Subject: FW: additional review material
Attachments: Combined Attachments Reduced.pdf

Subject: additional review material

42 Mill St Westwood, MA GEC Project Number 1826-5010

U.S. Drought Monitor **Northeast**

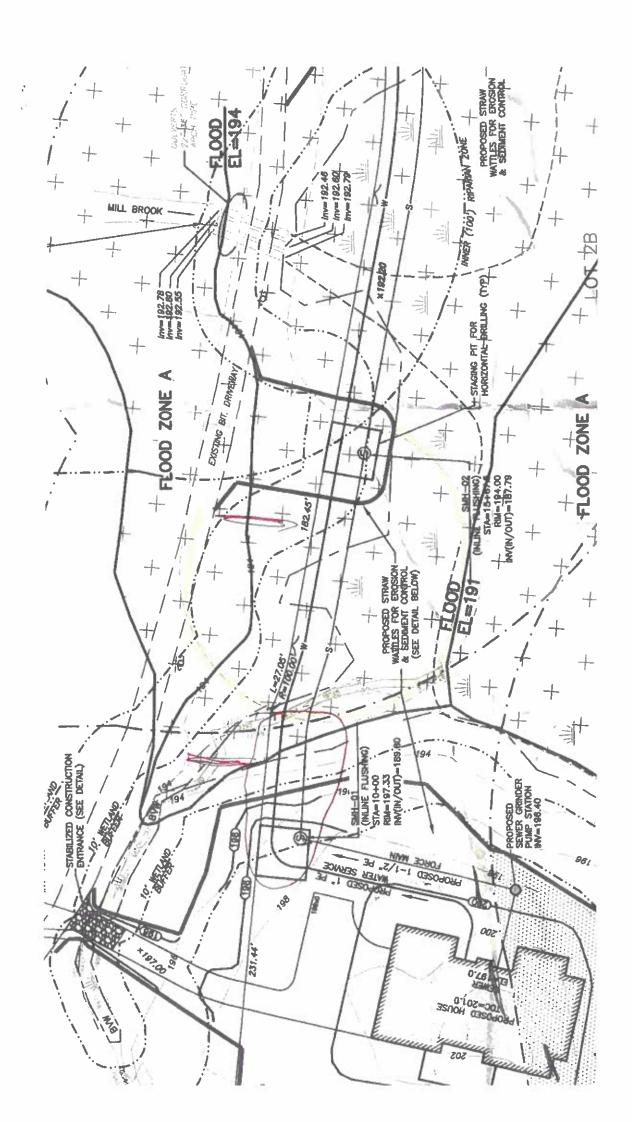
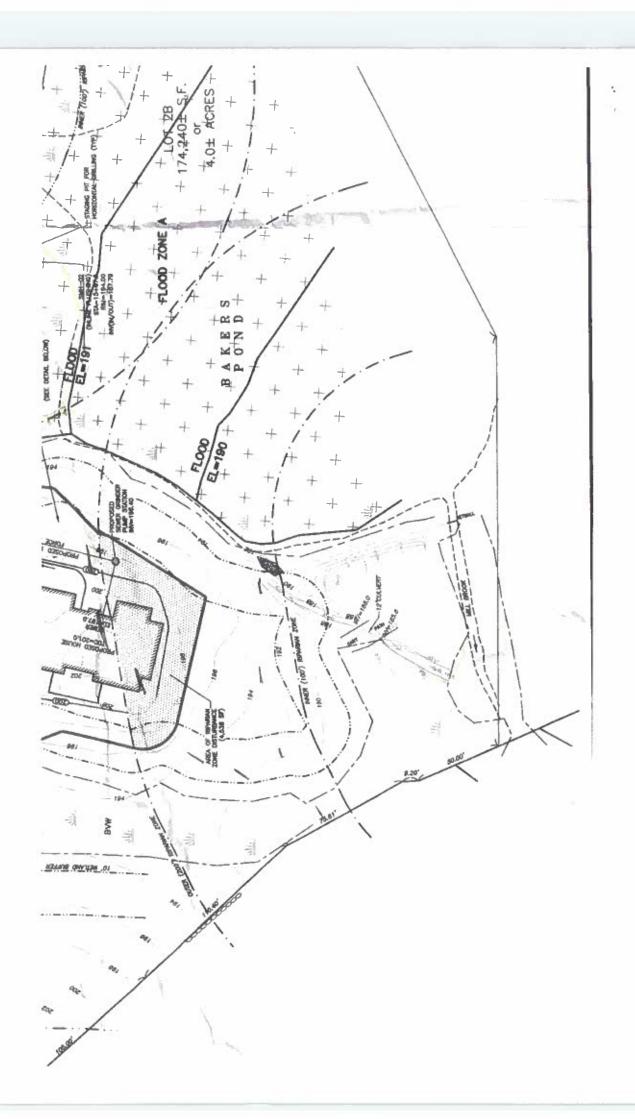
- G. Fall 2020 Drought monitor plan indicating extensive drought condition
- H. Plan of land submitted with application indicating the proposed access location is not from the Right of way but within abutter's property
